ADDENDUM ONE

Project No.: **24-006**

Subject: **CHANGES to the BIDDING DOCUMENTS**

Project: **RENOVATION PROJECT FOR
ORANGEVILLE CUSD #203
ORANGEVILLE, ILLINOIS**

H5 HEAD DETAIL
SCALE: 1-1/2"=1'-0"

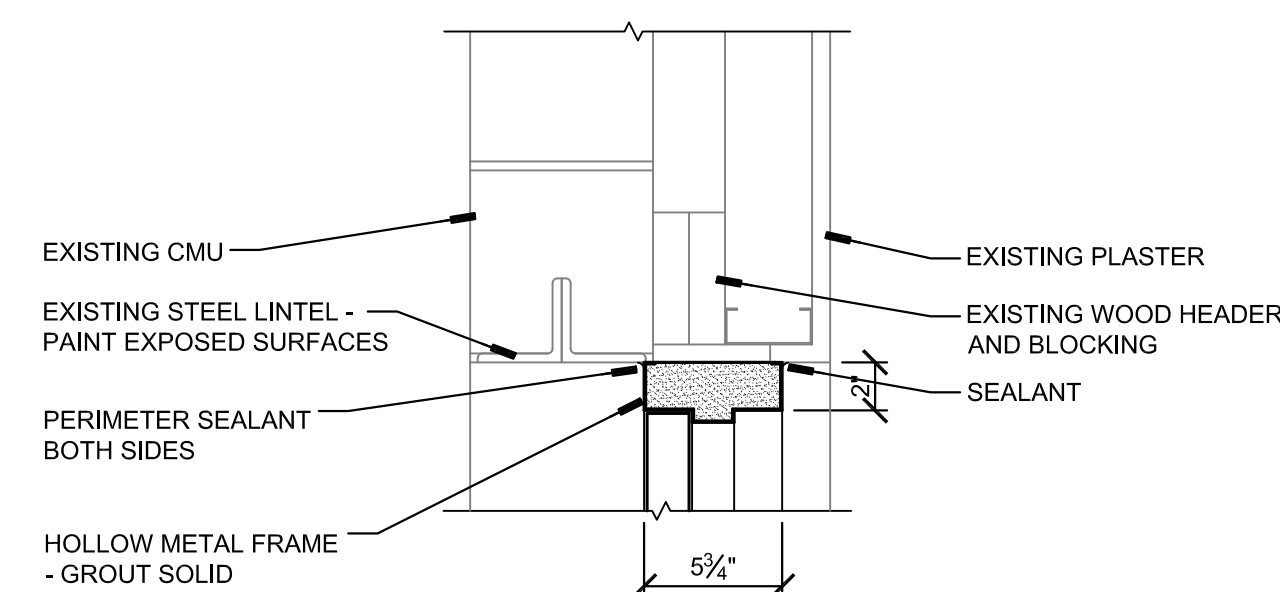
- 2.1. Head Detail H5 – See added note to paint the exposed cmu wall after the existing frame is removed under Alterante Bid #1.
